**COMMENTS & CONDITIONS MEMO**

**File:** C10E04.005 & 21T-13004B

**Subject:** **REQUIREMENTS FOR RESIDENTIAL DEVELOPMENT**  
**Application to Amend the Official Plan and Zoning By-law**  
**Amendment and Proposed Draft Plan of Subdivision**  
(To permit Residential and Office uses)  
Updated Comments from Parks & Facility Planning and Open Space  
Development Sections

**Location:** 8863 The Gore Road  
Part of Lot 4, Concession 10, Southern Division  
Circulation Date: September 11, 2017  
Ward: 8

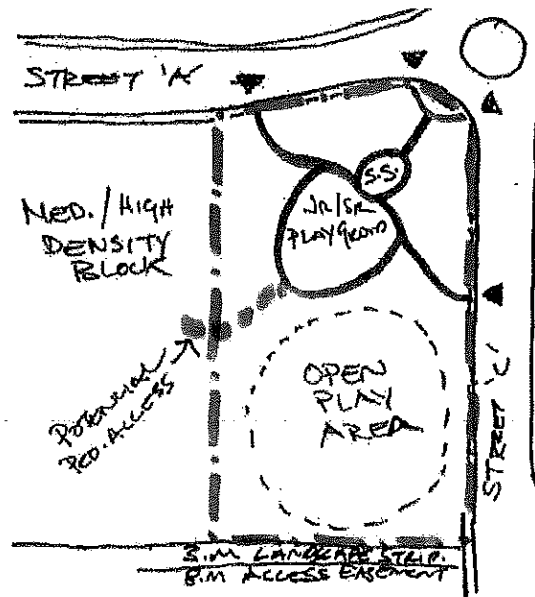
- 9.7. Change all reference noted as *"gateways"* to *"entry feature locations"* (i.e. pg. 21/B).
10. Pp. 22, Section 4.1.1.2 - Figure. 12
  - 10.1. Revise this section to ensure the 3m wide walkway blocks only have the proposed walkway and curbing on public land.

- 10.2. The proposed planting along the 3m wide walkway blocks should be removed, with the exception of columnar trees on private property.
  - 10.3. Revise the chain Link Fence note to add *"on private property"*.

- 10.4. Revise the Decorative Metal Fence with Masonry Columns note to add *"on private property"*.

- 10.5. Remove the Accent Trees.
- 10.6. Remove the one tree within the Street 'D' boulevard directly in front of the walkway block to allow for maintenance access.
- 10.7. Revise the Subsection write-up as per comments.
- 10.8. Change all reference noted as "*gateway*" to "*entry feature locations*" (i.e. pg. 23/4.1.1.3).
